SUBMISSION ON A NOTIFIED APPLICATION FOR A RESOURCE CONSENT

The proposed Activity and location of the application is:
RM220088 – application for an electronic digital sign at 47 The Esplanade, Petone

Submission RM220088 – L Skilton

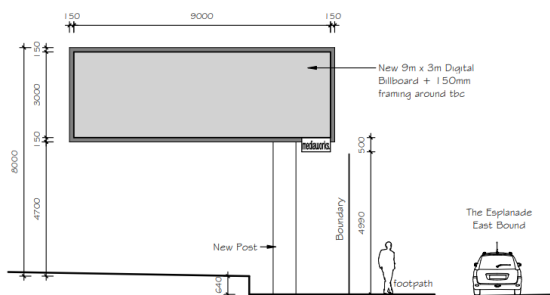
2. While the originally lodged application was for a portrait option sign, the documentation and updated plans has a landscape option also.
3. The original proposal was for a V-shaped double sided portrait digital sign. The sign will have a total height of 9.74m and each digital faced will have a height of 7.0m and a width of 3.5m. Each sign has a total area of 27.74m², or 55.48m² in total (including borders).

4. The updated plans also include an option for a V-shaped double sided landscape digital sign. The sign will have a total height of 8.64m and each digital faced will have a height of 3.0m and a width of 9.0m. Each sign has a total area of 30.69m², or 61.38m² in total (including borders).

15. The application includes an artist's impression of the proposed sign. In the background another large sign can be seen, showing the location of the Bunnings driveway. At my site visit of 11 October 2023, the sign was no longer there. I recommend that Council Officers determine the reason why the sign has been removed, as it may have been for safety concerns.
